**CITY OF MERIDIAN
FINDINGS OF FACT, CONCLUSIONS OF LAW
AND DECISION & ORDER**

Case No(s). H-2024-0019

COMMUNITY DEVELOPMENT DEPARTMENT REPORT

SUBJECT: H-2024-0019
Centrepont Apartments - ALT, CUP,
MDA

D. Proposed Site Plan (date: 9/26/2024)

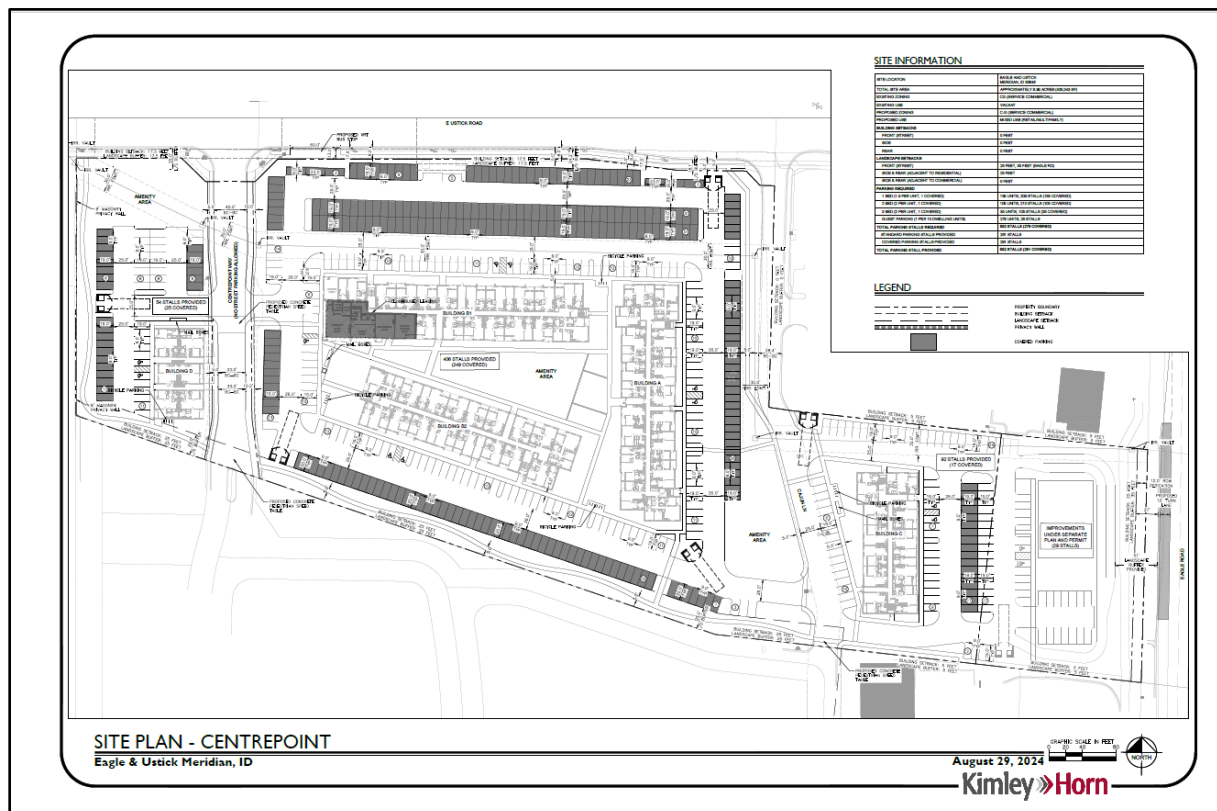
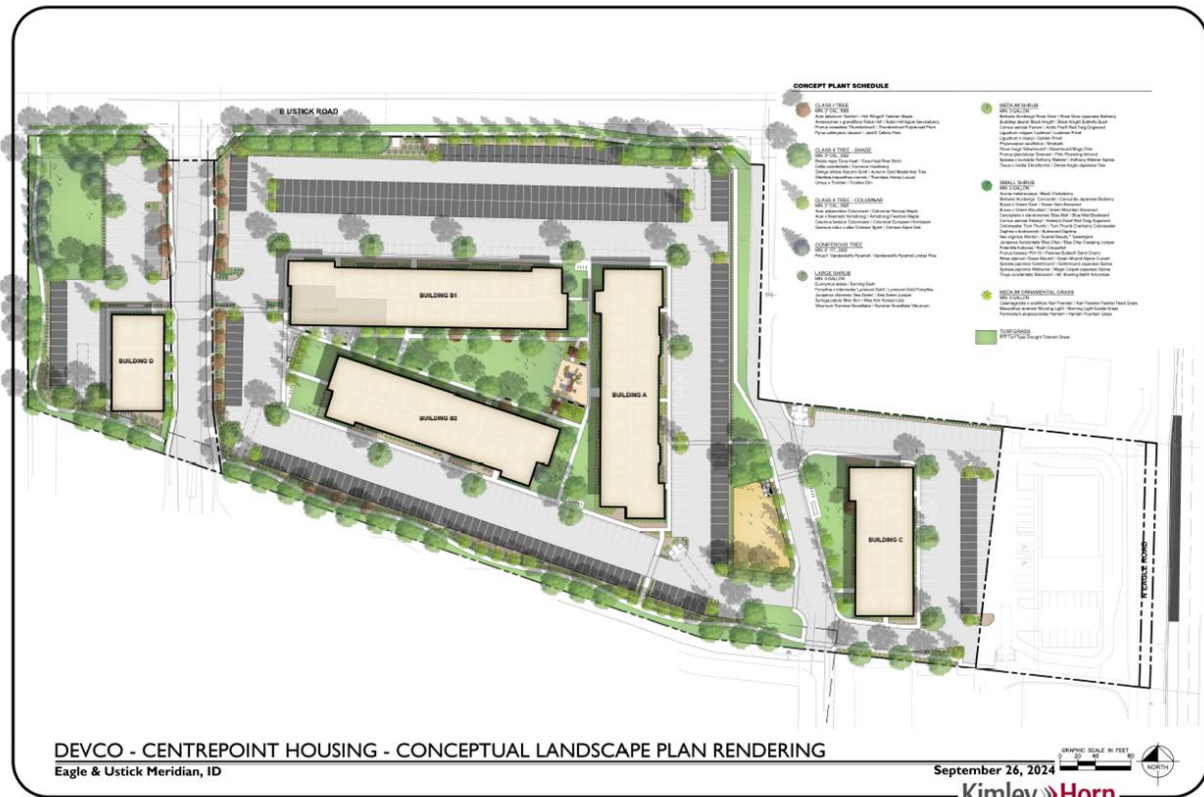
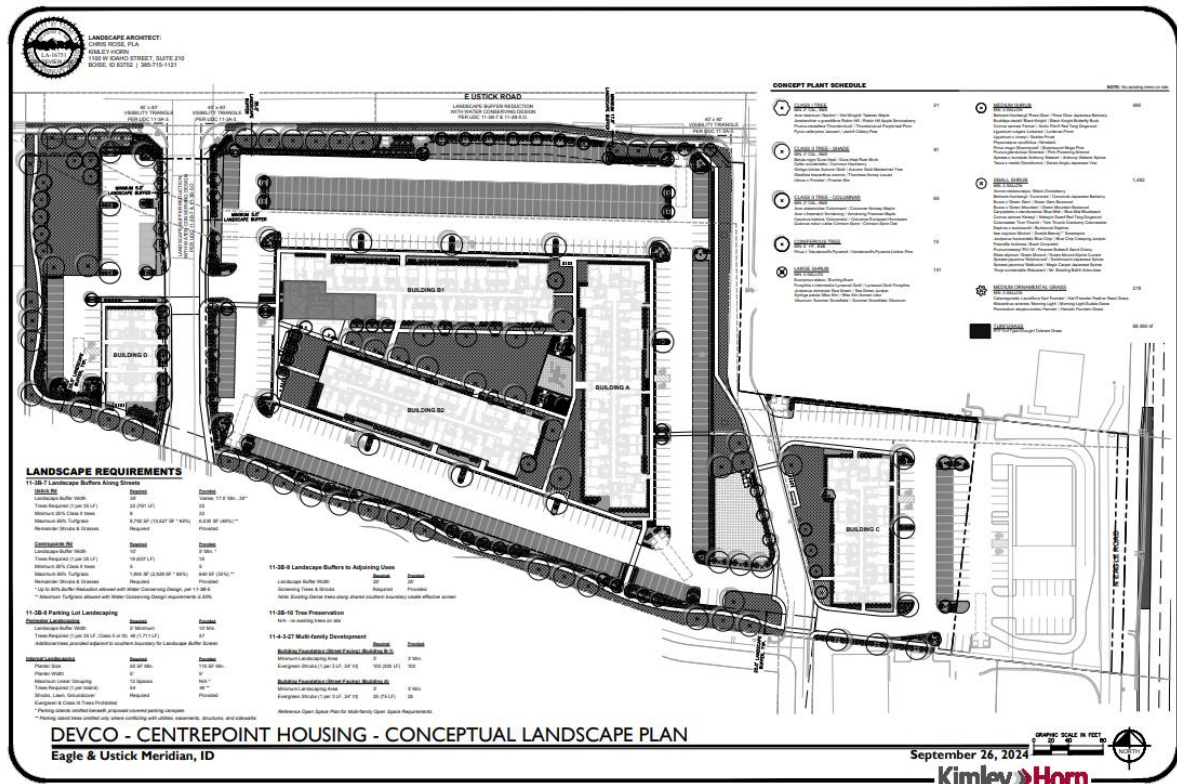
The submitted conceptual site plan (Exhibit VII.D) depicts five (5) multi-family buildings with internal access. The multi-family is split into three (3) 4-story buildings on the larger area of the site east of Centrepont Way, one (1) 4-story building west of Centrepont Way and one (1) 4-story building on the east side of Cajun Lane. The submitted landscape plan shows a 25-foot landscape buffer along the west and southern perimeter of the property.

Based on the analysis, staff feels the applicant is proposing too many units for development to be compliant with the Comprehensive Plan and UDC requirements. Staff feels if the proposal loses the parallel parking stalls along the north property line and relocate the open space away from Ustick Road, an arterial, it would be a nice addition to the community.

The applicant is requesting a modification to the existing DA to increase the number of units and increase the building height from three (3) stories to forty-five (45) feet in height instead of stories. Staff feels in order to maintain cohesiveness with the surrounding area, the building height should remain as shown on the proposed concept plan below.

Based on the submitted Site Plan, this requirement is met because none of the buildings are proposed closer than approximately 25 feet from any property boundary.

- a. Future development of the Residential Parcel shall be generally consistent with the proposed site plan, landscape plans and conceptual building elevations included in Section VII-D and VII-G and the provisions contained herein.

E. Landscape Plan (date: 9/26/2024)

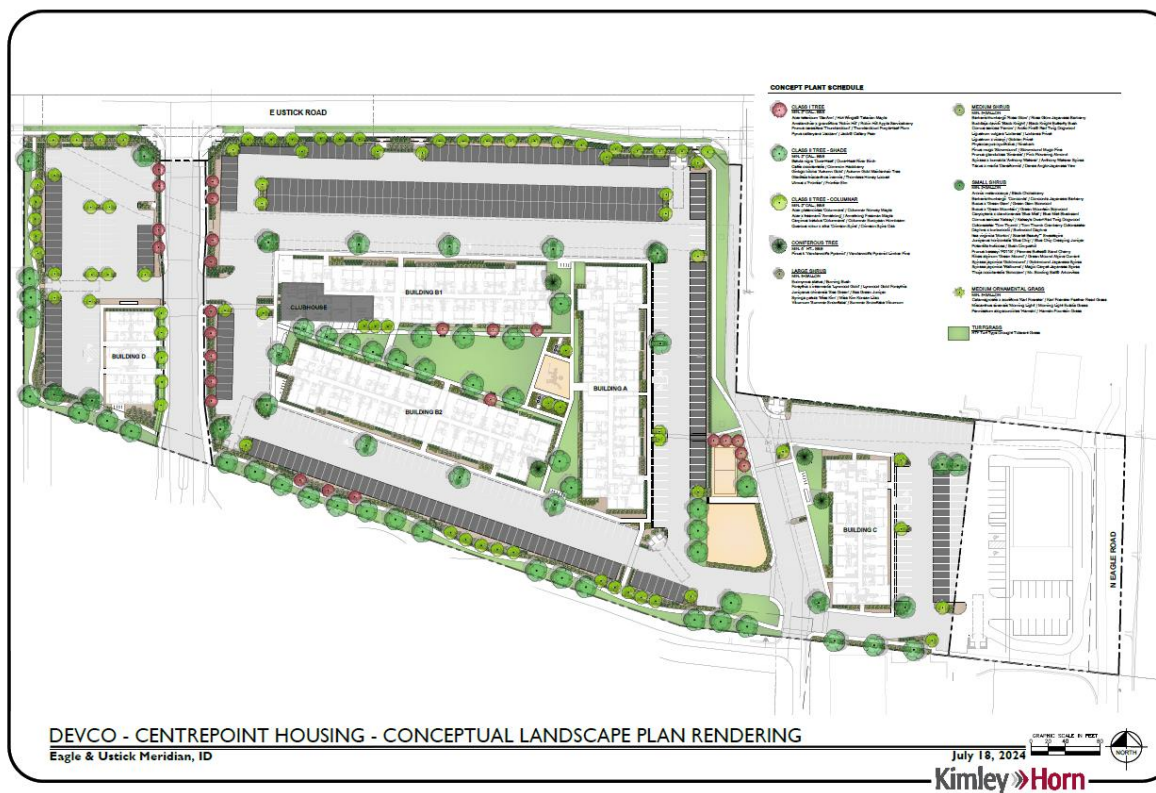
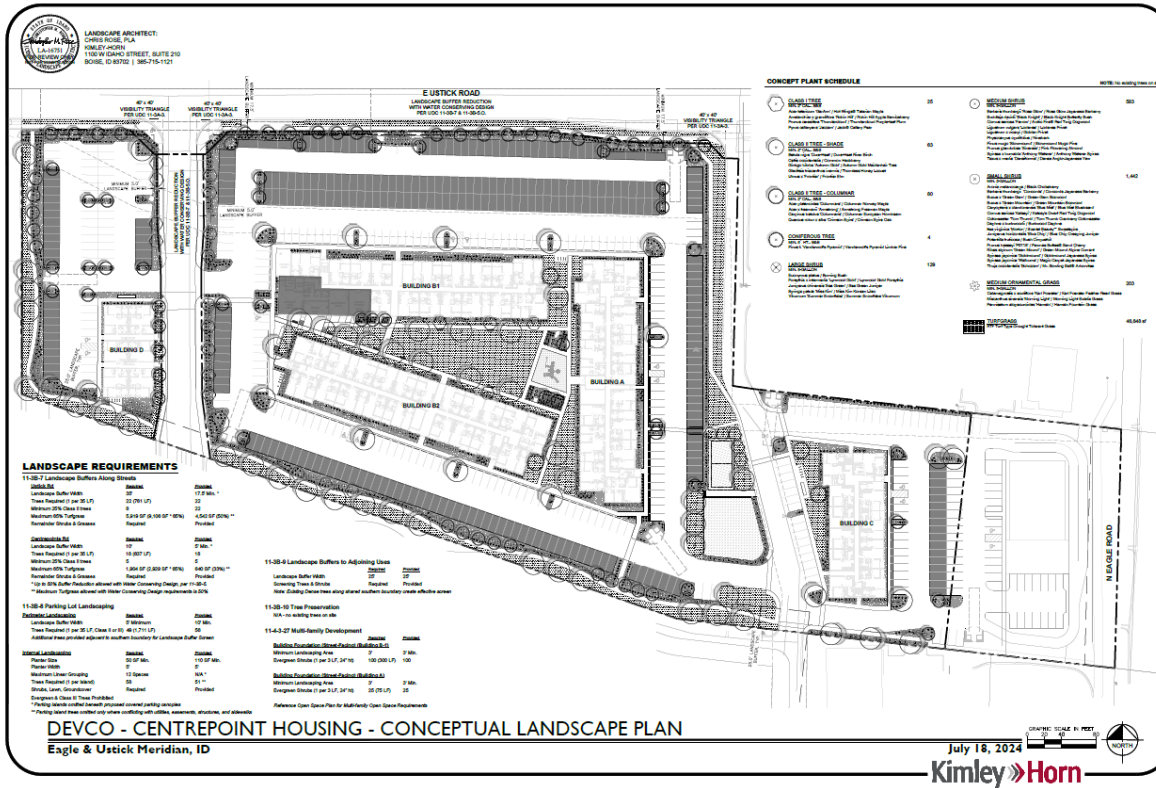
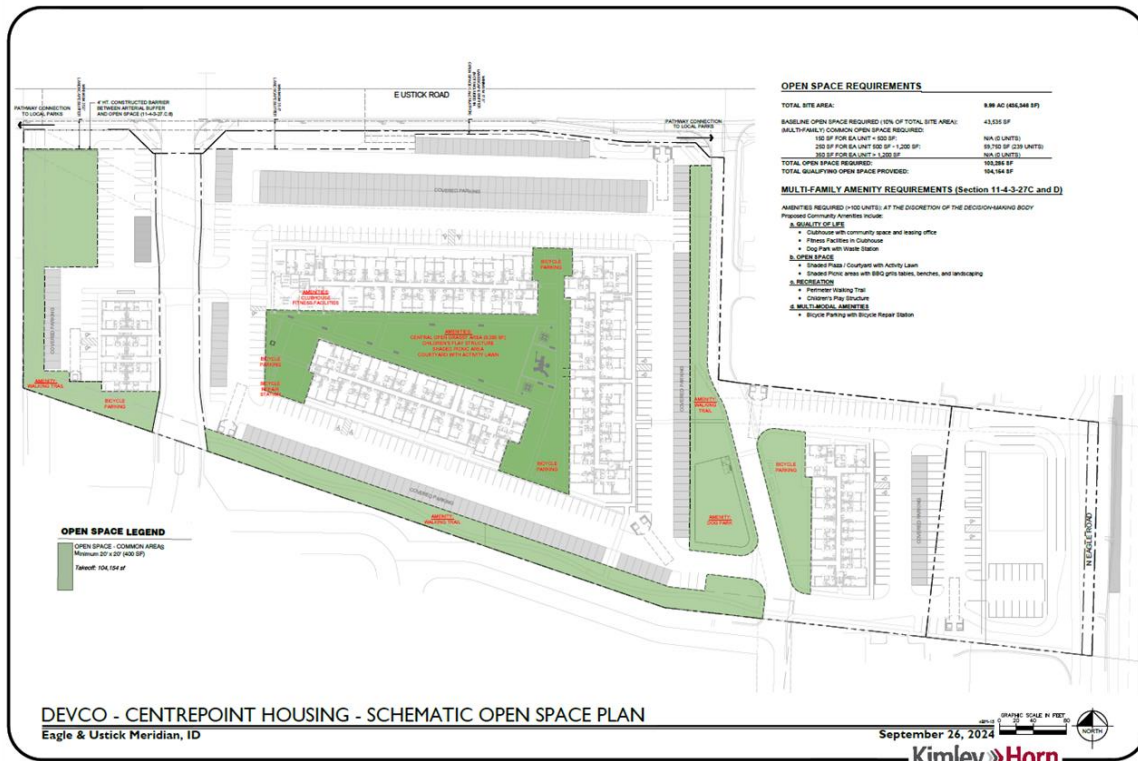
The applicant is proposing a reduction of the 35' wide landscape buffer along Ustick Road – up to a 50% reduction (17.5'), as allowed with the implementation of Water Conserving Design principles (UDC 11-3B-5.O). Staff has no objection to the applicant's request to provide a water conserving design for the street buffer along Ustick Road.

The applicant is proposing Alternative Compliance under UDC 11-3B-7.C.1.c to remove the parking lot islands beneath the covered parking areas within the development. Instead, the applicant plans to install solar carports, which will serve as a green infrastructure amenity by providing an alternative power source for the development and its residents. The solar carports will also fulfill the requirement for covered parking and help reduce the heat impact of the surface parking lot.

Staff finds the proposed landscape buffer adjacent to the residential neighborhoods meets the requirements of the UDC and requires a detail of the masonry wall to be submitted for review with the CZC application.

The applicant is proposing over 8,000 square feet of open grassy area adjacent to Ustick Road which is an arterial. The applicant is required provide an updated landscape plan fifteen day prior to the City Council public hearing showing how they meet this requirement unless otherwise waived by Council through the CUP process.

- 2.12 Upon completion of the landscape installation, a written Certificate of Completion shall be submitted to the Planning Division verifying all landscape improvements are in substantial compliance with the approved landscape plan as outlined in UDC 11-3B-14.
- 2.13 The Conditional Use Permit approval shall become null and void unless otherwise approved by the City if the applicant fails to 1) commence the use, satisfy the requirements, acquire building permits and commence construction within two years as outlined in UDC 11-5B-6F.1; or 2) obtain approval of a time extension as outlined in UDC 11-5B-6F.4.
- 2.14 The Director has approved the Alternative Compliance Request to remove the landscape island underneath the covered carports per UDC 11-3B-8.

F. Qualified Open Space Exhibit (date: 9/26/2024)

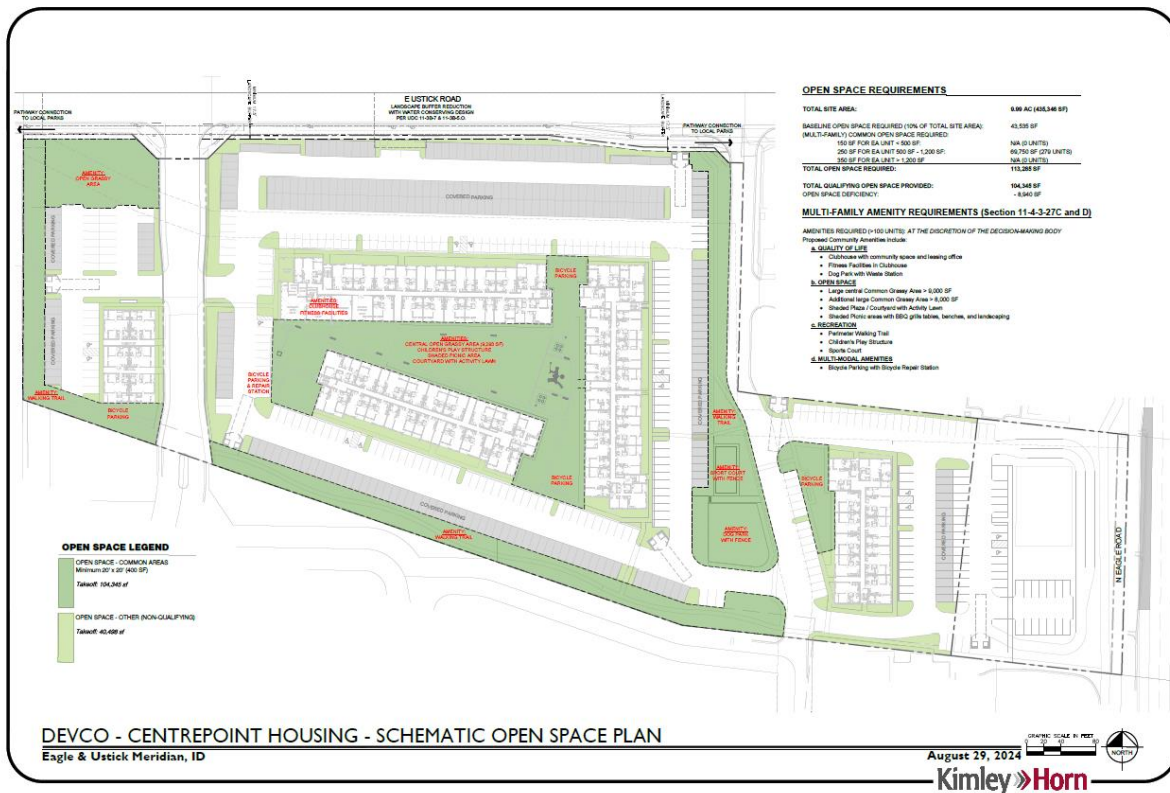
The proposed project will include 104,345 square feet of qualified open space which is 8,940 square feet less than required. The applicant is asking for alternative compliance for qualified open space requirement stating the site is irregular, has a unique targeted demographic of an affordable housing community, has significant indoor and outdoor passive and active amenities and excellent connectivity to public parks within walking distance. The project also includes an extensive network of pedestrian oriented pathways including an outer loop around the entire project with internal connections to the various amenities for the project allowing for free movement of pedestrians throughout the site.

The submitted plans depict two (2) open common grassy areas 8,000 - 9,000 square feet, above the required 5,000 square foot minimum. Although the Applicant is providing amenities above code requirements within this development, the development is deficient in the required amount of qualified open space.

Per the property size and the unit counts and their sizes, the minimum open space required to be provided is 113,266 square feet (approximately 2.60 acres). According to the submitted open space exhibit and landscape plans, the project is deficient by approximately 8,940 square feet of qualified open space. The applicant is requesting alternative compliance stating the site has an additional 40,498 square feet of non-qualifying landscape area, pathways, and buffer landscape area not included in the qualifying calculation.
